Our Reference: 21616/A5/EIA Letter
10th February 2023

RE: LANCASHIRE CENTRAL (LCC/2022/0044) – LANDSCAPE AND VIEWS LETTER OF COMPLIANCE

Application No: LCC/2022/0044	Consultation Ref No: N/A
Proposed Development/Plan/Project: Application for Outline Planning Permission (with all matters reserved save for access from the public highway and strategic green infrastructure/landscaping) for a mixed-use development including the provision of Employment use (Use Classes B2/B8/E(g)); retail (use Class E(a)); food, drink and drive-through restaurant use (Use Class E(b)/Sui Generis Drive-Through); hotel use (Use Class C1); health, fitness and leisure use (Use Classes E(d)/F(e)/F2(b)); creche/nursery (Class E(f)); car showrooms (Use Class Sui Generis Car Showroom); Residential use (C3) the provision of associated car parking, access, public open space, landscaping and drainage.	
Location: Cuerden Strategic Site, East of Stanifield Lane, North of Clayton Farm, West of Wigan Road, Lostock Hall	
District: South Ribble	
Type of Consultation: Planning application	Date: 22/11/2022

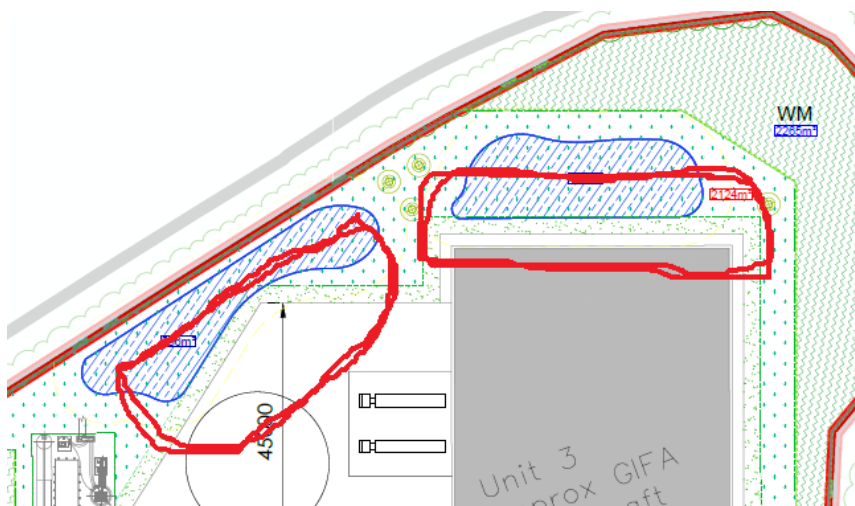
- The landscaped areas along the frontage of these access roads are too narrow for planting to achieve any meaningful mitigating effect. They also fail to maintain the applicant's 'boulevard' concept for the main access roads:

- An inadequate separation distance has been provided between the two ponds and adjacent structures (see the area's bounded by red lines in the screenshot below). Maintaining the northern end of Unit 3 could be compromised by the limited space between it and the nearby pond. If these ponds are intended to be beneficial for biodiversity, then some form of buffer should be provided between them and nearby service areas and buildings:

Also of concern in the screenshot above is the lack of space around much of the western pond for maintenance.

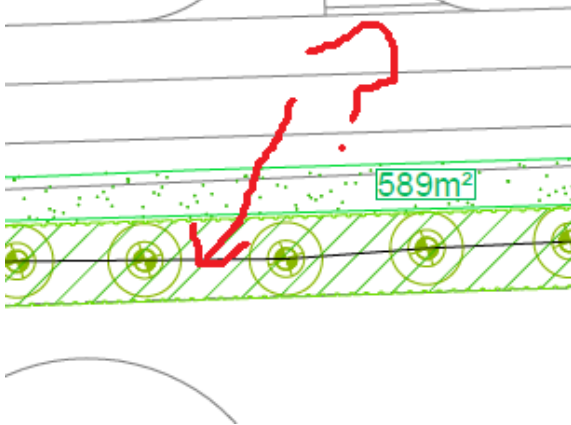
- Unlike the other landscape proposals drawings, the building units do not have the grey hatching and building unit number.
- Of concern are the inadequate mitigation planting proposals along the northern, eastern and – in part – southern boundaries. Along the northern boundary only grassland and *one* tree are proposed. As the land beyond this is to be developed for housing, mitigation of the effects of the proposed large industrial buildings on views from the residential area is essential. As can be seen in the screenshot below, the applicant's proposals would result in clear unfiltered views of the large northern building and associated service area from the adjoining residential area:

Stanifield Lane frontage

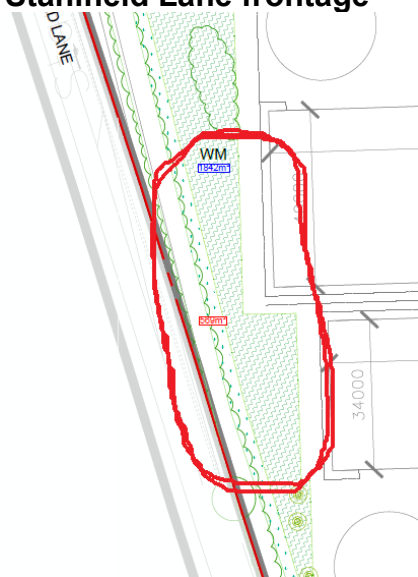
- Substantial belts of woodland are proposed to mitigate effects and assimilate the scheme into the local landscape, but at critical locations no planting of heavy or extra heavy standard trees are proposed. In the example locations below, larger trees are essential to achieve an immediate impact in the opening year:

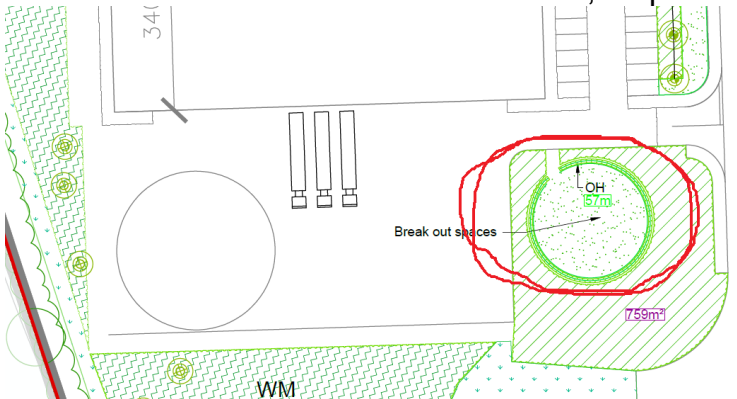
- The location of the proposed large building leaves no space in the area highlighted below for any effective mitigation planting. The proposed ornamental hedge which would be dwarfed by the adjacent large industrial building would do little other than highlight the inadequacy of the mitigation provided:
